#### **43 BARROW STREET**

Landmarks Preservation Commission Hearing March 14, 2023

### Based on the Public Hearing on January 31, 2023, we were asked to address the following major points:

## proposed section with sight lines

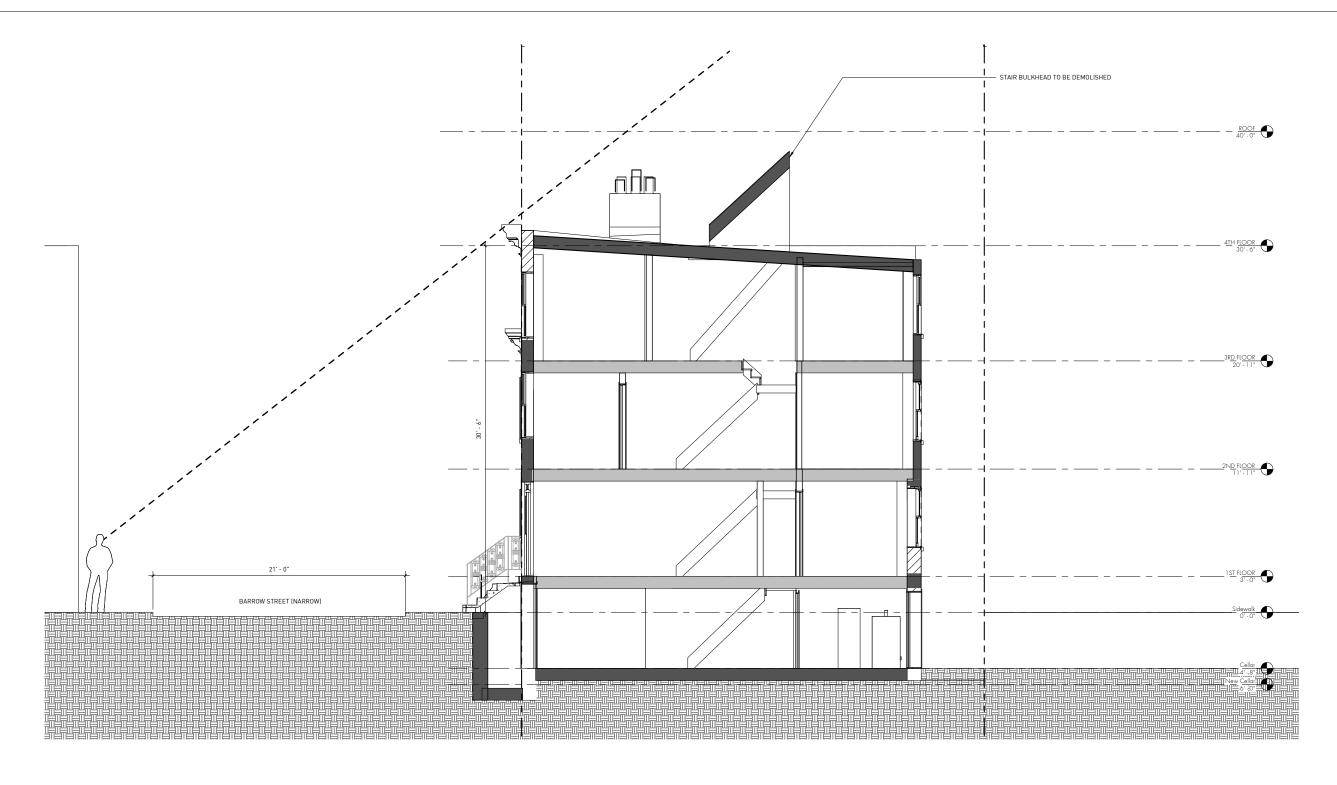
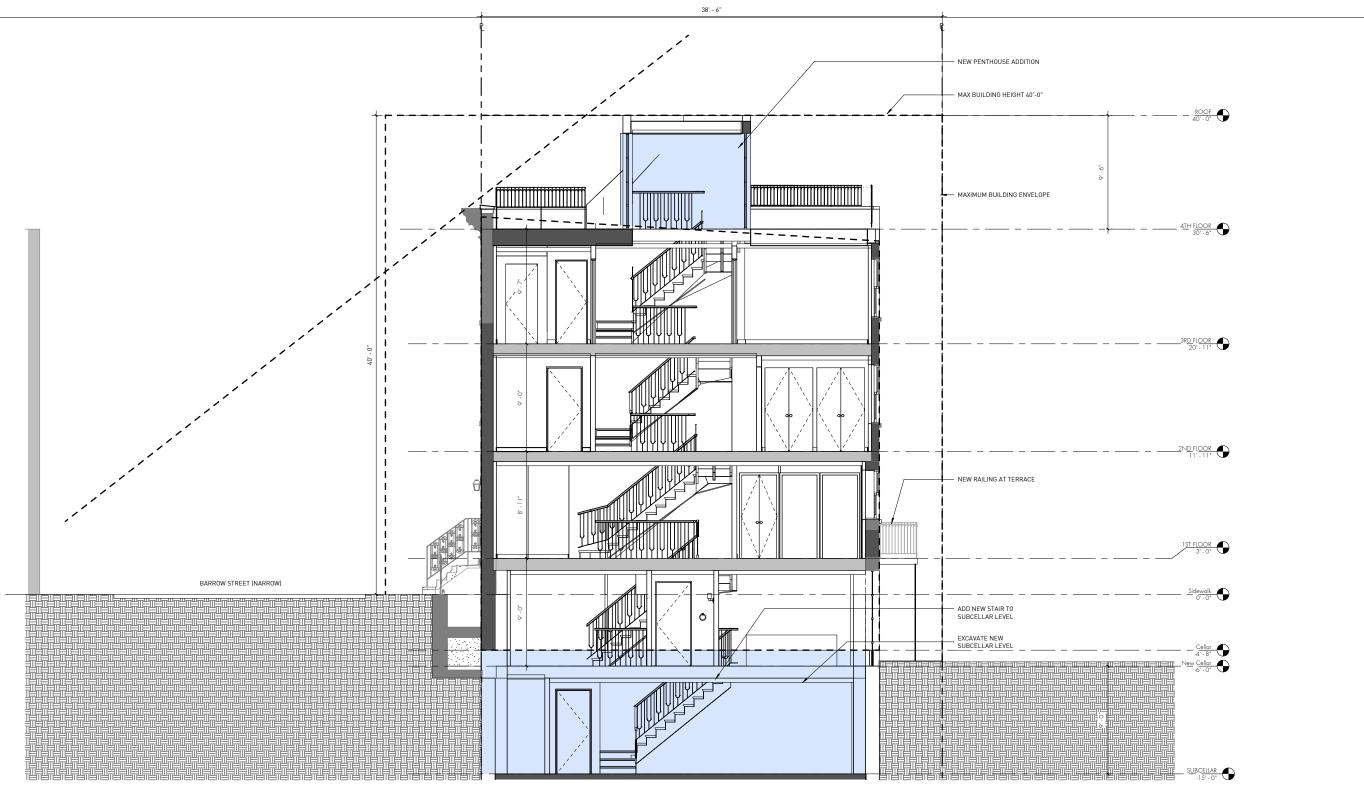
# previously proposed section with sight lines

- Cut addition back six feet at the rear.
- Simplified overall volume.
